RE: JMC Project 23050
 Majidi Subdivision
 21 Whippoorwill Road
 Town of North Castle, NY
 Tax Lot 107.04-1-11

Response to Comment Memoranda Received KSCJ Consulting

INTEGRATED PLOT PLAN
MAJIDI SUBDIVISION
21 WHIPPOORWILL ROAD
NORTH CASTLE, NY 10504

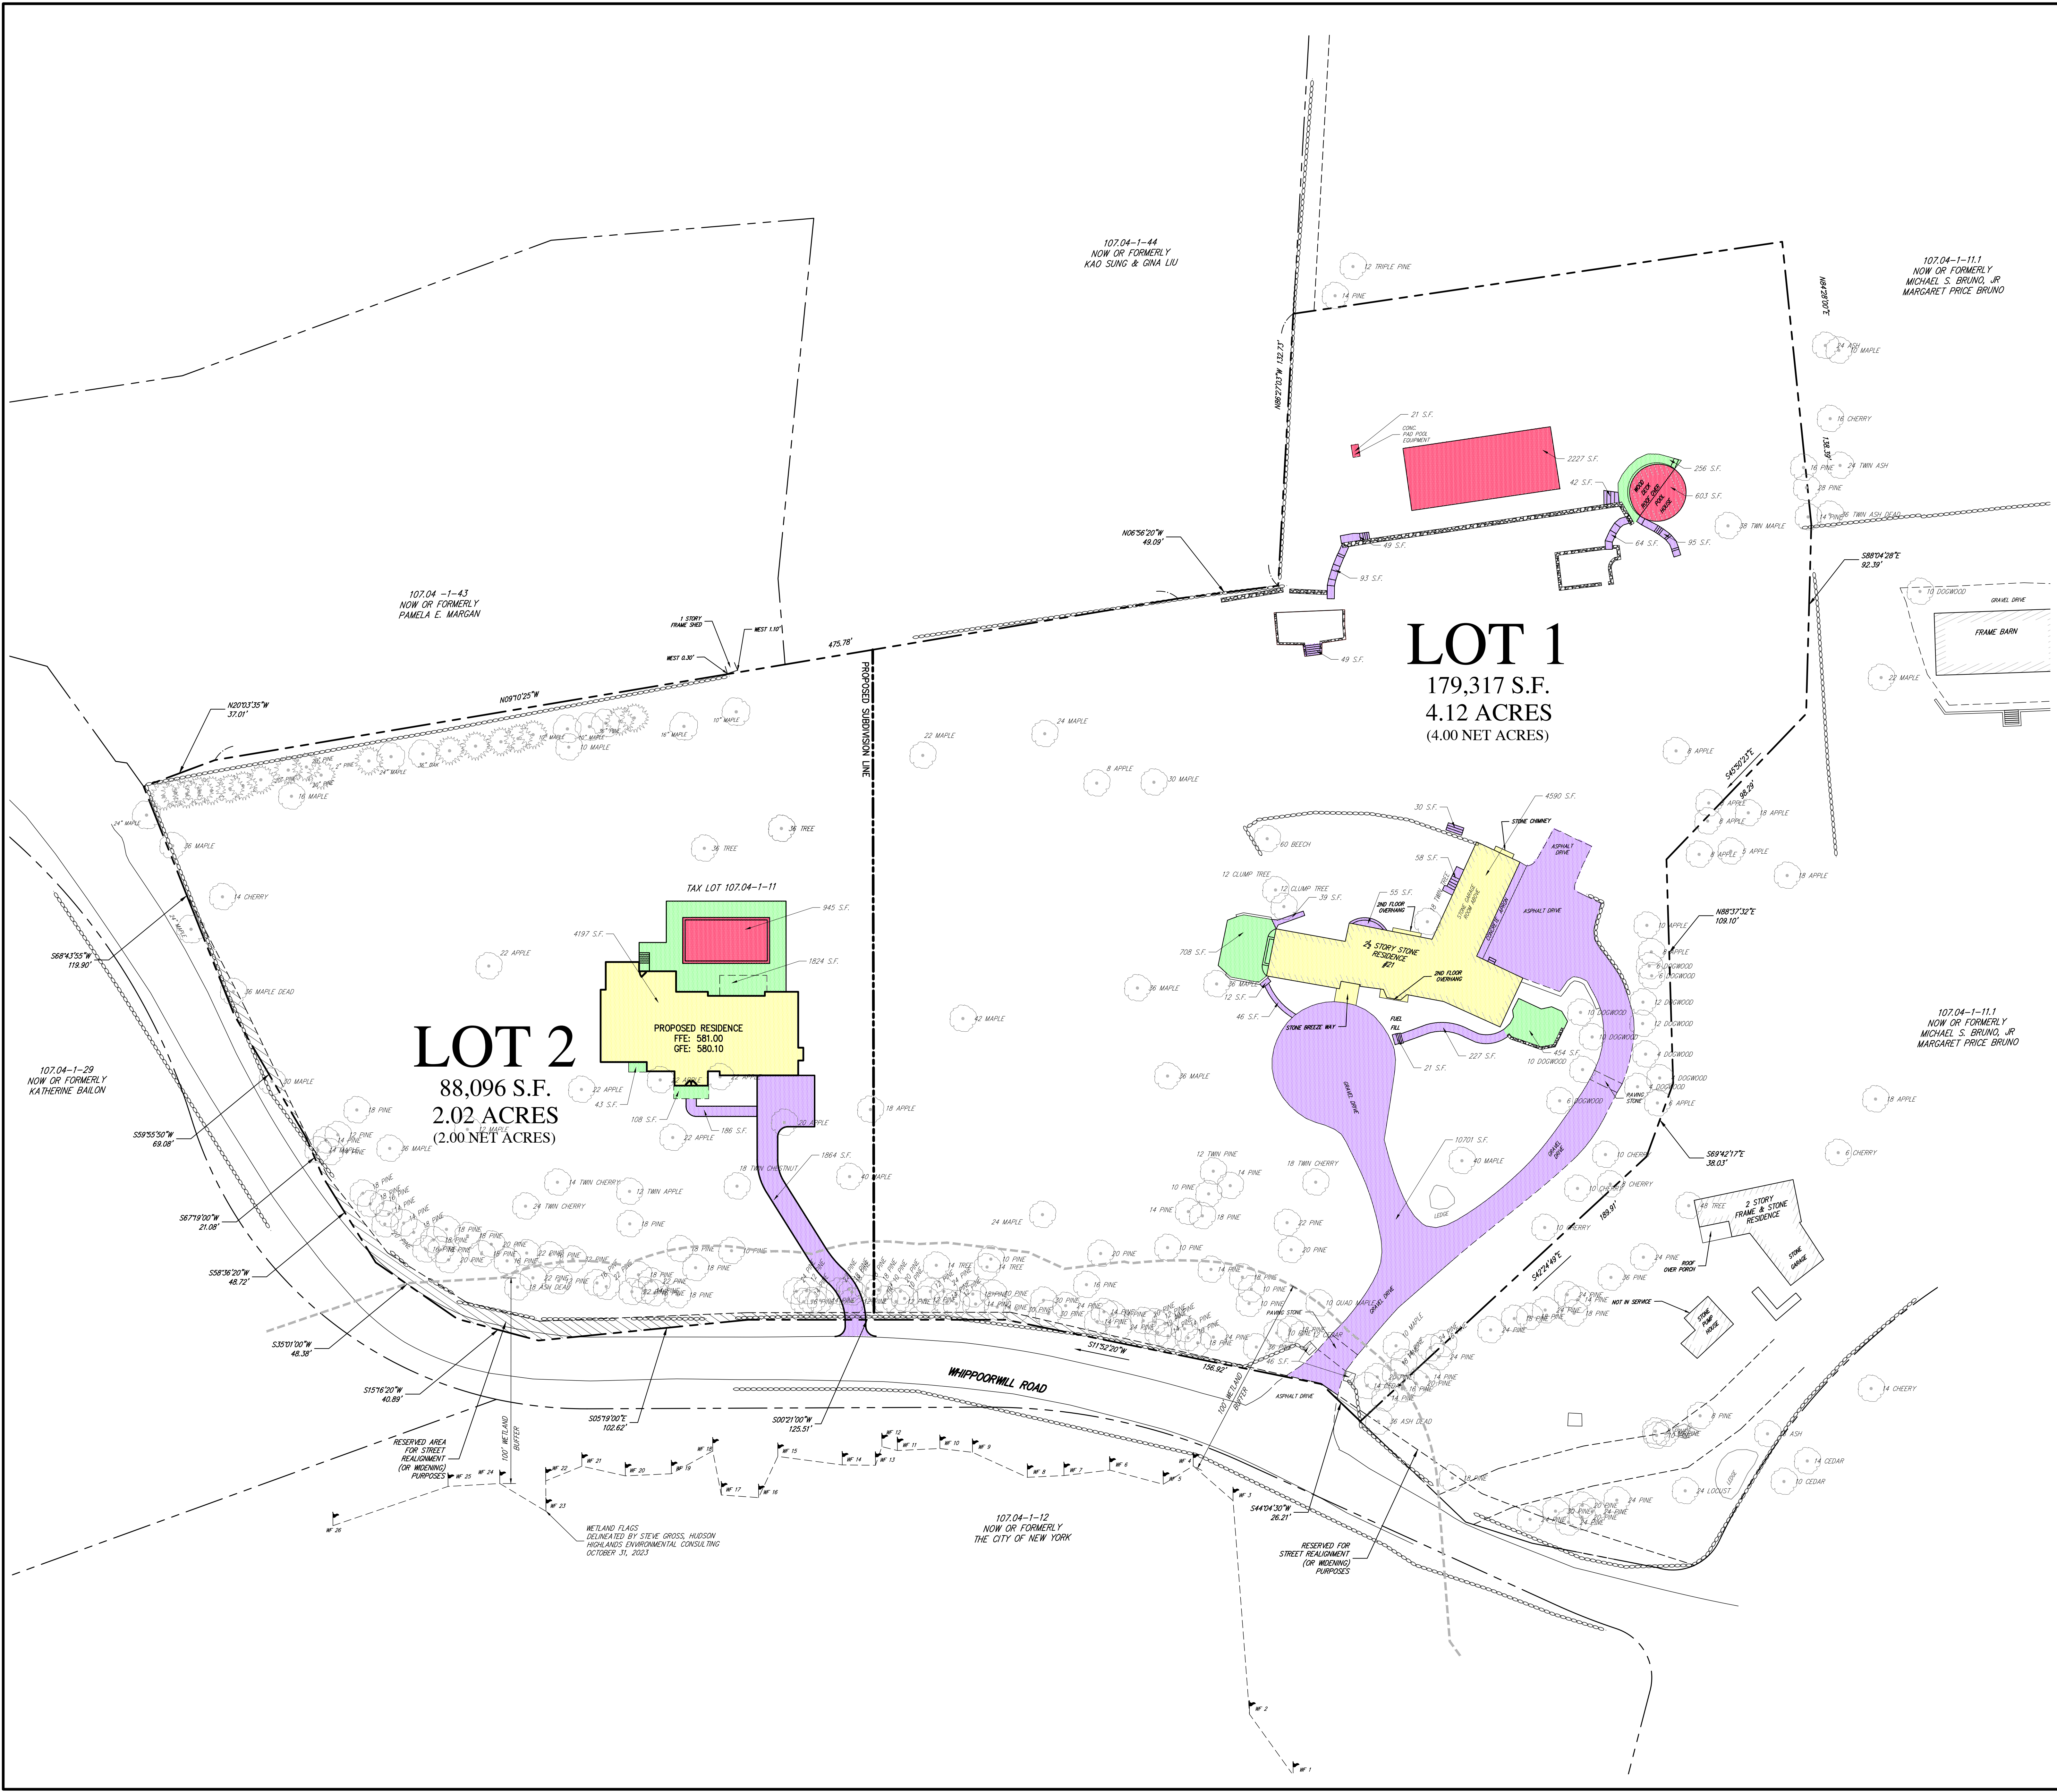
The applicant shall provide sight distance profiles for the proposed driveway demonstrating adequate sight lines for a minimum distance of 200 feet in each direction, as required by

the Town Code. The plans shall illustrate any proposed site improvements required to achieve the sight distance.

Sight lines to the south viewing oncoming traffic from the south, from the proposed driveway and sight lines for vehicles traveling from the south viewing vehicles turning into the proposed driveway from the south is restricted by vegetation and grades along the property frontage. The applicant is using a driver's eye elevation of 580 feet; however, the actual elevation appears closer to 578.5 feet. The applicant should prepare a detailed plan of how safe sight lines of 200 feet can be obtained.

The applicant should examine relocating the driveway curb cut further to the north in the vicinity of the proposed northern property line, where sight lines could likely be obtained with much less clearing and grading to the south.

The applicant has shifted the driveway entrance to the north, however, not a sufficient distance to provide safe stopping sight lines for vehicles traveling northbound on Whippoorwill Road. The curve along Whippoorwill Road South of the driveway is in close proximity to the driveway entrance. Drivers from the south will not see a vehicle stopped within the roadway waiting to turn into the driveway until they have rounded the curve. I have driven this road every day for over 30 years and know a drivers eye is focused on the narrow curve ahead and not activity 90 degrees to their left. The applicant should relocate the driveway entrance further to the north adjacent to the northern property line, a distance which will avoid the necessity of removing the stone wall along the property frontage.

The proposed driveway has been shifted approximately 20 feet to the north, adjacent to the northern property line as suggested. This adjustment minimizes the amount of existing stone wall to be removed while still achieving the required site distance.

CONCEPTUAL GRADING AND UTILITIES PLAN
MAJIDI SUBDIVISION
21 WHIPPOORWILL ROAD
NORTH CASTLE, NY 10504

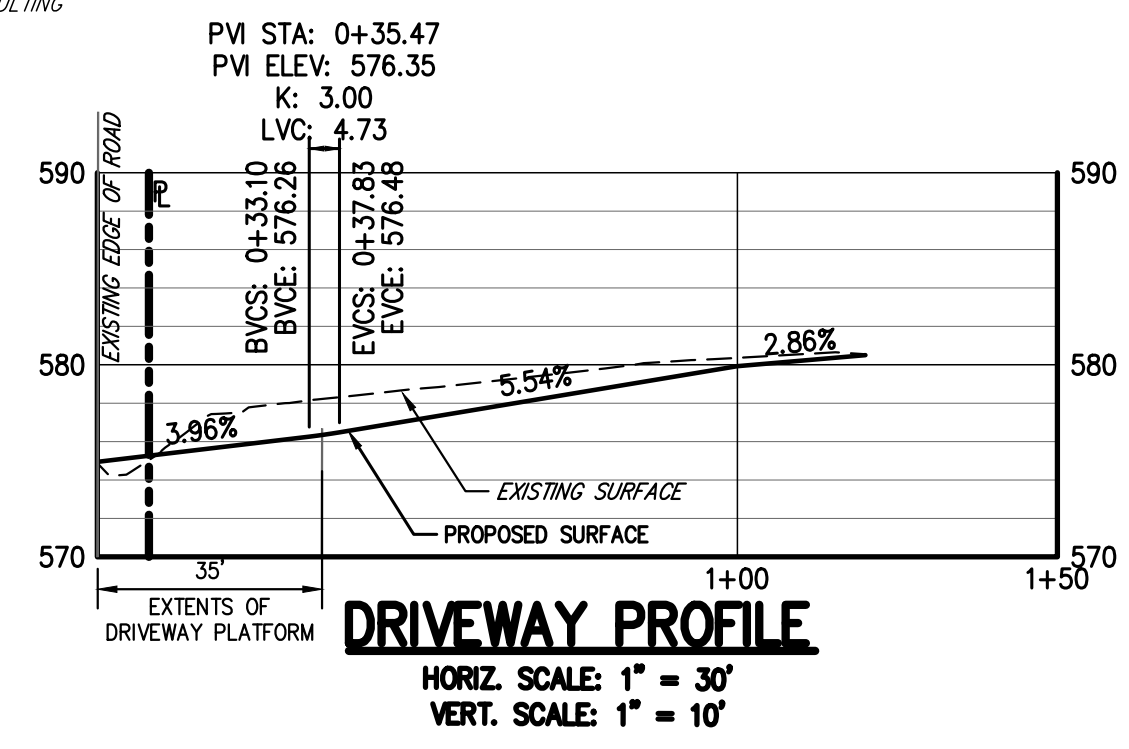
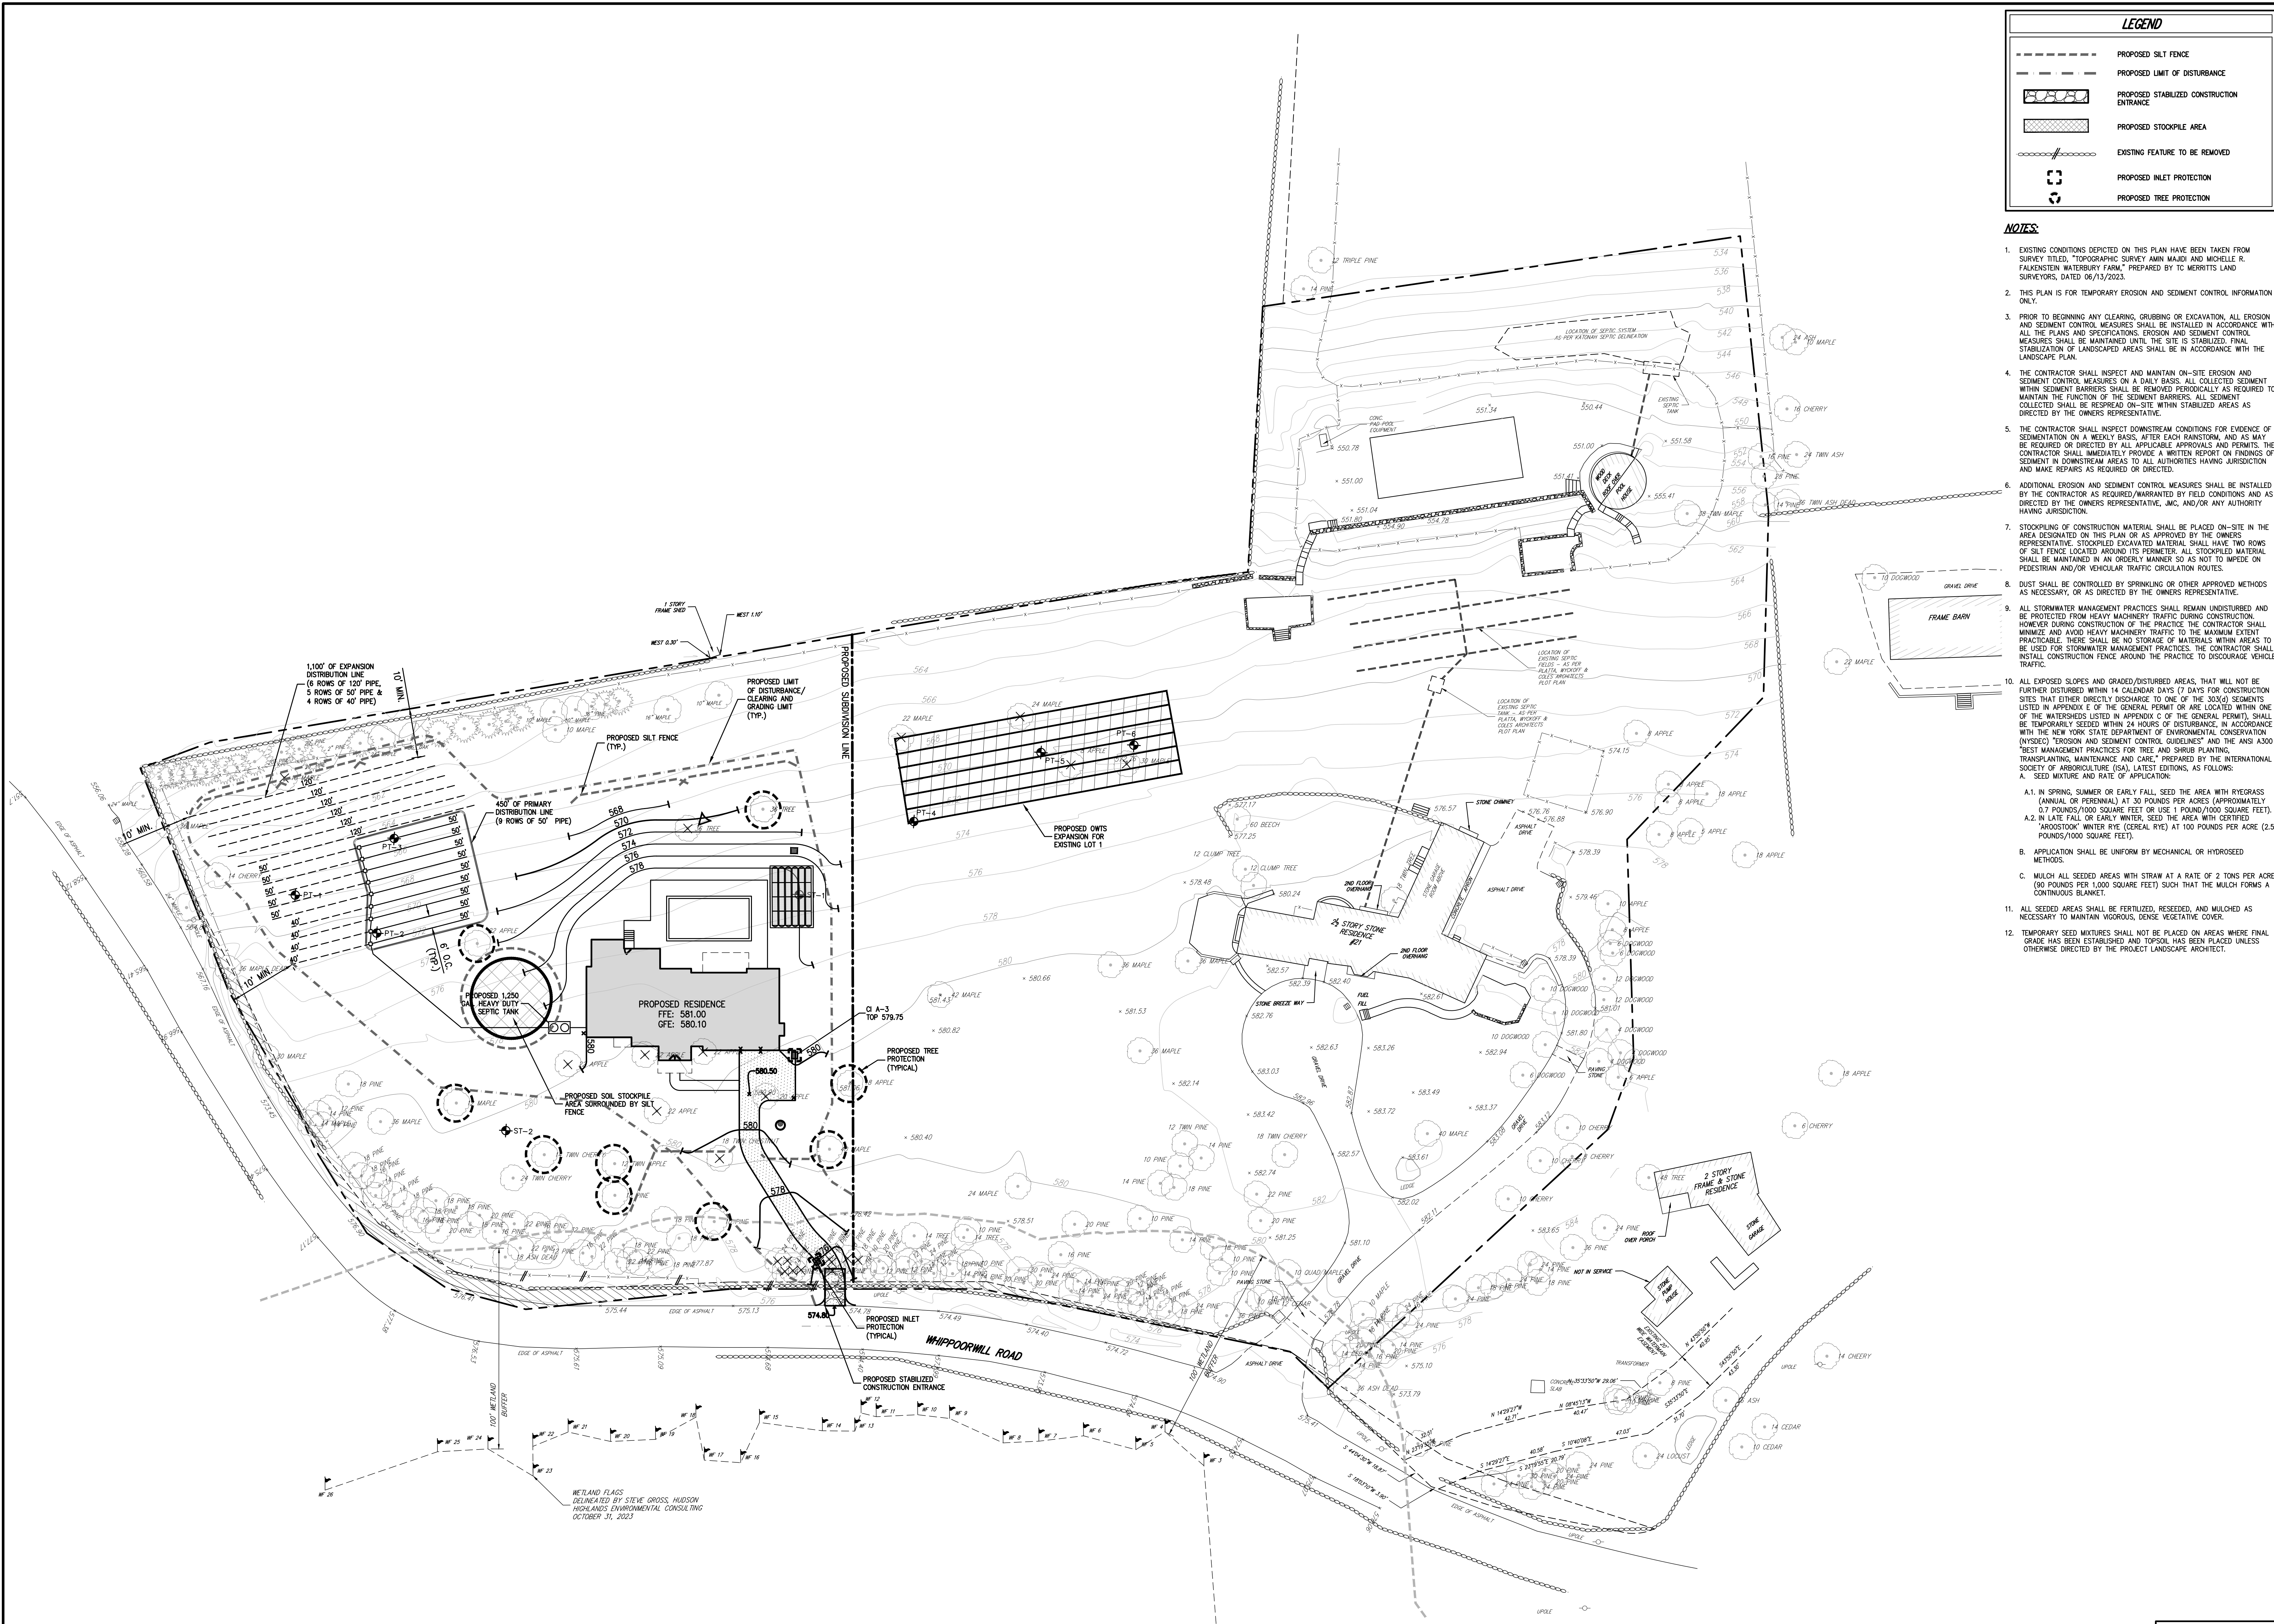
- *The stormwater analysis evaluated a 25-year storm event. The applicant should revise the analysis to address a 100-year storm event.*
- *The applicant states that the system was amended to address the 100-year storm event, however, calculations were not provided and the size of the system appears unchanged.*
- *The proposed drainage area is stated as 0.21 acres in area, while the existing drainage area is 0.11 acres. The applicant should explain this difference.*

The applicant states that the calculations were amended, however, the amended calculations were not submitted.

- *The proposed stormwater treatment system will be installed at a depth of eight (8) feet below grade. Such conditions will require soils with no bedrock or groundwater down to a depth eleven (11) feet below existing grade. The applicant should perform soil testing within the area of the proposed stormwater treatment system to verify that adequate soil conditions exist to mitigate the stormwater.*

The applicant requests performing soil testing at a later date. Testing is necessary to confirm that mitigation can be provided as proposed, and therefore should be performed prior to subdivision approval.

- *Stormwater discharge from the treatment system is directed towards the neighboring residence to the west. Stormwater discharge should be dispersed in a direction which will not impact neighboring homes.*

The applicant notes that discharge from the site will be reduced upon installation of the stormwater mitigation. Discharge in the proposed condition, however, will be a concentrated point discharge which is directed at the neighboring home. The point discharge should be dispersed in a direction which will not impact neighboring homes.

The applicant performed soils testing on 01/17/2024 with representative from KSCJ consulting. The soil testing results are attached to this submission and the accompanying plans and calculations have been updated. JMC has revisited the overflow of the underground drainage system to employ a drain inlet overflow surrounded by rip-rap to alleviate a point discharge directed at the neighboring residence.
